1	<b>Encoding Guide Edition 2.4 Request for:</b> <input type="checkbox"/> <b>an addition</b> (e.g. new picture, new coding instruction or new real world entity, which is encoded by already existing object classes, attributes and attribute values, but requires no alteration of existing elements) <input type="checkbox"/> <b>a change</b> (e.g. replacing a picture, illustration or an already existing text) <input checked="" type="checkbox"/> <b>an addition/change that affects the Feature Catalogue (edition 2.4)</b>		
2	Sections A and B  This is a request <input type="checkbox"/> referring to lit. <input type="checkbox"/> for a new lit.  <i>(Continue with 4 on this page)</i>	Sections C to U  This is a request <input type="checkbox"/> referring to page(s) (e.g.: C.1.5) of the Encoding Guide <i>(Continue with 3 on this page)</i> <input checked="" type="checkbox"/> for a new page in section O.2 (e.g.: E.1) of the Encoding Guide <i>(Continue with 6 on this page and add the proposal on page 2 after removing form protection)</i>	Section V to Z and Annexes AA to AF  This is a request <input type="checkbox"/> referring to section <i>(Continue with 4 on this page)</i> <input type="checkbox"/> fo

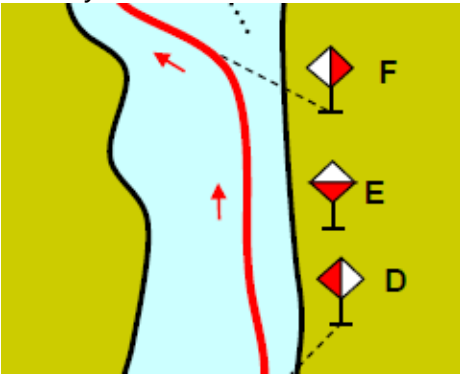
3	<input type="checkbox"/> Definition <input type="checkbox"/> Picture: <input type="checkbox"/> real world <input type="checkbox"/> paper chart <input type="checkbox"/> IENC <input type="checkbox"/> Coding instruction lit. <input type="checkbox"/> Object coding of object class <input type="checkbox"/> Illustration		
4	Proposed addition/change:		
5	Proposed picture/illustration: Attach the file to the form, please. Name of file:		
6	Explanation, why this amendment/change is needed: This addition is needed because the notice marks, used to indicate the fairway in the river Po, are not included in the ECDIS standard, and therefore they cannot be correctly represented and displayed on IENC maps. On the other hand, Po river notice marks cannot be easily replaced by standard notice marks or daymarks: the Po river is a free flow river, which bed morphology changes very frequently, and the fairway trace changes as well. Notice marks needs therefore to be frequently moved or changed, and, in order to save money and time, they have been designed as a single element. The meaning of the marks depends therefore on the positioning and on the rotation of this unique element: a white and red rhombus.

Used only in the Po river (Italy). Indicates that the recommended track changes to the other side of the waterway. The white half of the mark shows the direction to be followed

7	Proposed amendments to the Feature Catalogue: Addition to the 'catlam' attribute: 24 (change bank), 25 (continue along bank)		
8	Proposed amendments to the Inland ENC domain in the S-100 registry: Addition to the 'catlam' attribute: 24 (change bank), 25 (continue along bank)		
9	Proposed amendments to the Recommended Validation Checks for IENCs: Allows the new values of 'catlam'		
10	Proposed applicability: <i>mark all applicable boxes</i> <input type="checkbox"/> US <input type="checkbox"/> Europe (without Russia) <input type="checkbox"/> Russia <input type="checkbox"/> South America <input type="checkbox"/> Asia  Italy (Po river) <i>(description of an other area of applicability, e.g. a country)</i>		
11	Name of sender: Luca Crose  Name of authority or company: AIPo (Interregional Agency for the river Po)  e-mail address: luca.crose@agenziapo.it  Date (2013/11/18):	Deadline for comments 2013/12/30 (6 weeks)  To be filled in by a member of the Core Group: <input checked="" type="checkbox"/> <b>Proposal adopted</b> / <input type="checkbox"/> Proposal rejected Will become part of edition 2.4 of the EG.

Graphics	Encoding Instructions	Object Encoding
<p><i>Real World</i></p>  <p><i>Chart Symbol</i></p>  <p><i>IENC Symbolization</i></p> 	<p>A) 'Change bank' marks are used in pairs (two equal marks, one on each bank); the alignment of the two marks indicates the track to be followed for crossing the river. Single 'change bank' marks are only used in combination with the 'touch and go' mark.</p> <p>B) Referring to navigation in the downstream direction, if it is placed on the right bank it indicates that you have to move to the other bank; if it is placed on the left bank, it indicates that you have to approach the bank. Ships must always move in the direction indicated by the white triangle</p> <p>C) COLOUR = [1 (white), 3 (red)] when, navigating in the downstream direction, the ship has to move to the left bank, or when navigating in the upstream direction, the ship has to move to the right bank</p> <p>D) COLOUR = [3 (red), 1 (white)] when, navigating in the downstream direction, the ship has to move to the right bank, or when navigating in the upstream direction, the ship has to move to the left bank</p>	<p><b><u>Object Encoding</u></b></p> <p><b>Object Class</b> = bcnlst(P)</p> <p>(M) BCNSHP = [1 (stake, pole, perch, post)]</p> <p>(M) catlam = [24 (change bank)]</p> <p>(M) COLOUR = ["Unknown" or 1 (white), 3 (red), 4 (green), ]</p> <p>(M) SCAMIN = [EU: 22000]</p> <p>(C) SORDAT = [YYYYMMDD]</p> <p>(C) SORIND = (Refer to Section B, General Guidance)</p> <p><b>Coding of Equipment Object</b></p> <p><b>Object Class</b> = DAYMAR(P)</p> <p>(M) COLOUR = [1 (white), 3 (red)]</p> <p>(M) TOPSHP = [12 (rhombus (diamond))]</p> <p>(M) COLPAT = [2 (vertical stripes)]</p> <p>(C) INFORM = (Refer to TOPSHP above)</p> <p>(O) CONDTN = [1 (under construction), 2 (ruined), 3 (under reclamation), 5 (planned construction)]</p> <p>(M) SCAMIN = [EU: 22000]</p> <p>(C) SORDAT = [YYYYMMDD]</p> <p>(C) SORIND = (Refer to Section B, General Guidance)</p>

### O.2.7 Continue along bank (M)

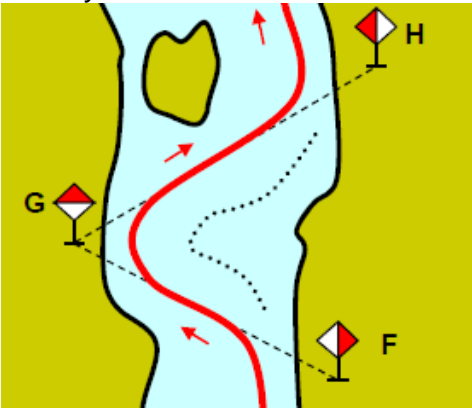
Used only in the Po river (Italy). Indicates that the recommended track continues along the same side of the waterway.

Graphics	Encoding Instructions	Object Encoding
<p><i>Real World</i></p>  <p><i>Chart Symbol</i></p>  <p><i>IENC Symbolization</i></p> 	<p>A) 'Continue along bank' Marks are used to indicate that the recommended track continues along the bank on which it is placed</p> <p>B) Referring to navigation in both directions, it generally follows a 'Change bank' Mark</p> <p>C) It is repeated about every 0.5 km, until the next 'Change bank' Mark</p> <p>D) In this case COLOUR has to be always encoded as [1,3]</p>	<p><b><u>Object Encoding</u></b></p> <p><b>Object Class</b> = bcnlat(P)</p> <p>(M) BCNSHP = [1 (stake, pole, perch, post)]</p> <p>(M) catlam = [25 (continue along the bank)]</p> <p>(M) COLOUR = ["Unknown" or 1 (white), 3 (red), 4 (green), ]</p> <p>(M) SCAMIN = [EU: 22000; US: 60000]</p> <p>(C) SORDAT = [YYYYMMDD]</p> <p>(C) SORIND = (Refer to Section B, General Guidance)</p> <p><b>Coding of Equipment Object</b></p> <p><b>Object Class</b> = DAYMAR(P)</p> <p>(M) COLOUR = [1 (white), 3 (red)]</p> <p>(M) TOPSHP = [12 (rhombus (diamond))]</p> <p>(M) COLPAT = [1 (horizontal stripes)]</p> <p>(C) INFORM = (Refer to TOPSHP above)</p> <p>(O) CONDTN = [1 (under construction), 2 (ruined), 3 (under reclamation), 5 (planned construction)]</p> <p>(M) SCAMIN = [EU: 22000]</p> <p>(C) SORDAT = [YYYYMMDD]</p> <p>(C) SORIND = (Refer to Section B, General Guidance)</p>

### O.2.8 Touch and go (M)

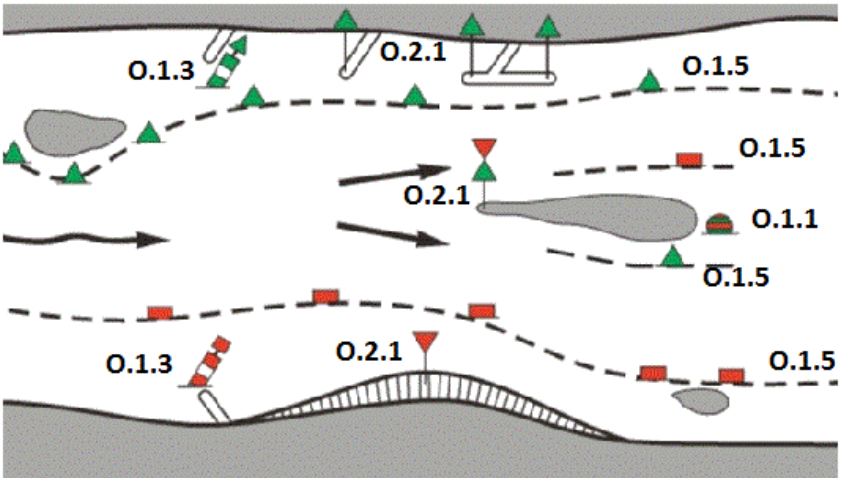
Used only in the Po river (Italy). Indicates that the ship has to reach the bank and immediately move to the other bank

Graphics	Encoding Instructions	Object Encoding
<p><i>Real World</i></p>  <p><i>Chart Symbol</i></p>  <p><i>IENC Symbolization</i></p> 	<p>A) It is used instead of two consecutive 'Change bank' Mark, which should be placed very close on the same bank, to indicate that the recommended track changes again to the previous side of the waterway.</p> <p>B) Is preceded and followed by two 'Change bank' Marks, both on the opposite bank of the waterway.</p> <p>C) In this case COLOUR has to be always encoded as [3,1]</p>	<p><b><u>Object Encoding</u></b></p> <p><b>Object Class</b> = bcnl(P)</p> <p>(M) BCNSHP = [1 (stake, pole, perch, post)]</p> <p>(M) catlam = [24 (change bank)]</p> <p>(M) COLOUR = ["Unknown" or 1 (white), 3 (red), 4 (green), ]</p> <p>(M) SCAMIN = [EU: 22000; US: 60000]</p> <p>(C) SORDAT = [YYYYMMDD]</p> <p>(C) SORIND = (Refer to Section B, General Guidance)</p> <p><b>Coding of Equipment Object</b></p> <p><b>Object Class</b> = DAYMAR(P)</p> <p>(M) COLOUR = [1 (white), 3 (red)]</p> <p>(M) TOPSHP = [12 (rhombus (diamond))]</p> <p>(M) COLPAT = [1 (horizontal stripes)]</p> <p>(C) INFORM = (Refer to TOPSHP above)</p> <p>(O) CONDTN = [1 (under construction), 2 (ruined), 3 (under reclamation), 5 (planned construction)]</p> <p>(M) SCAMIN = [EU: 22000]</p> <p>(C) SORDAT = [YYYYMMDD]</p> <p>(C) SORIND = (Refer to Section B, General Guidance)</p>

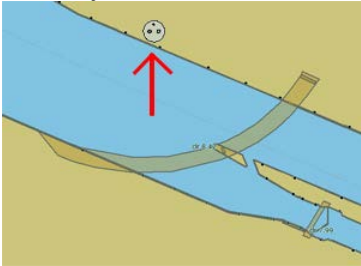
3	<input type="checkbox"/> Definition <input type="checkbox"/> Picture: <input type="checkbox"/> real world <input type="checkbox"/> paper chart <input type="checkbox"/> IENC <input type="checkbox"/> Coding instruction lit. <input checked="" type="checkbox"/> Object coding of object class BCNISD, BCNLAT, bcnl <input type="checkbox"/> Illustration		
4	Proposed addition/change: Add attribute ORIENT (optional) for beacons (BCNISD, BCNLAT, bcnl - except RTPBCN Radar transponder beacon)		
5	Proposed picture/illustration: Attach the file to the form, please. Name of file:		
6	Explanation, why this amendment/change is needed: Presently ORIENT is allowed for all notice marks. Notice marks and beacons both stand on land and should be represented the same way. To stay consistent ORIENT should also be allowed for beacons. This way we could enhance the visibility of the chart. We would exclude radar transponder beacons because the symbols looks like buoys which are not rotated. The beacon linked DAYMAR symbols should be oriented with the same angle.

Presently ORIENT is allowed for all notice marks. Notice marks and beacons both stand on land and should be represented the same way. To stay consistent ORIENT should also be allowed for beacons.

As far as I know, the ORIENT attribute for notice marks is only used for the "A.1 - no entry" and on bridge marks so they can be rotated according the orientation of the bridge. Beacons are always displayed upright, why should we change this?

- 1) "Only used for bridge marks": a) the Feature Catalogue 2.3 allows ORIENT for ALL notice marks b) The latest Encoding Guide 2.3.6 allows ORIENT not only for bridge marks, but also in general - O.3.1. In Brazil you even HAVE to use ORIENT for ALL notice marks.
- 2) "always displayed upright - why change?" The post makes the beacon symbol much bigger - therefore it should be rotatable, so that objects below are not covered, e.g. here a groin (at a bigger scale!) or other objects like notice marks. It doesn't make sense to zoom and zoom, until other objects are clearly identifiable.

As far as I know in the example symbol set the symbols that were allowed to have ORIENT were vector symbols. The others were bitmaps. Does ORIENT work on bitmap symbols? Or have these symbols been converted to vector symbols already?

First of all, I didn't say ORIENT is not allowed on other notice marks, it's not used for displaying them. Pieta is right, rotation of raster symbols is not supported in Preslib 3.4.

Mr. Wieland Haupt presents the change request concern an extension of the optional attribute ORIENT to beacons. The attribute shall also be usable for beacons which can also be on the shoreline and seen from water. It's mainly intended for future use. Mr. Marc Persoons thinks that this CR will need new development on side of the IECDIS viewer applications so from manufacturer side more arguments or examples would be good to better show the benefits. Mr. Haupt replies that the CR is not urgent and could be delayed. He will try to provide more examples and pictures in the future. Mr. Birkhuber adds that the CR would also have broader consequences since the encoding guide limits for which notice marks the attribute is applicable. So also the encoding guide would need to be updated. Mr. Birkhuber states that ORIENT should not be used for all notice marks. Mr. Laszlo Redly supports the CR since the attribute is only optional.

Mr. Birkhuber warns that the intention of the Encoding Guide was to ensure that IENCs are encoded in the same way throughout Europe. It would create confusion if the same notice marks and beacons would be encoded with ORIENT in one country and without in another one.

7	Proposed amendments to the Feature Catalogue: add ORIENT to BCNISD, BCNLAT and bcnl		
8	Proposed amendments to the Inland ENC domain in the S-100 registry: add ORIENT to BCNISD, BCNLAT and bcnl		
9	Proposed amendments to the Recommended Validation Checks for IENCs: allow ORIENT for BCNISD, BCNLAT and bcnl		
10	Proposed applicability: <i>mark all applicable boxes</i> <input checked="" type="checkbox"/> US <input checked="" type="checkbox"/> Europe (without Russia) <input checked="" type="checkbox"/> Russia <input checked="" type="checkbox"/> South America <input checked="" type="checkbox"/> Asia  <i>(description of an other area of applicability)</i>		
11	Name of sender: Wieland Haupt Name of authority or company: FGS Regensburg e-mail address: wieland.haupt@wsv.bund.de Date (YYYYMMDD): 20140602	Deadline for comments 20140714 (6 weeks)  To be filled in by a member of the Core Group: <input type="checkbox"/> Proposal adopted/ <input type="checkbox"/> Proposal rejected Will become part of edition 2.4 of the EG.

**The CR will be updated by Mr. Haupt.**
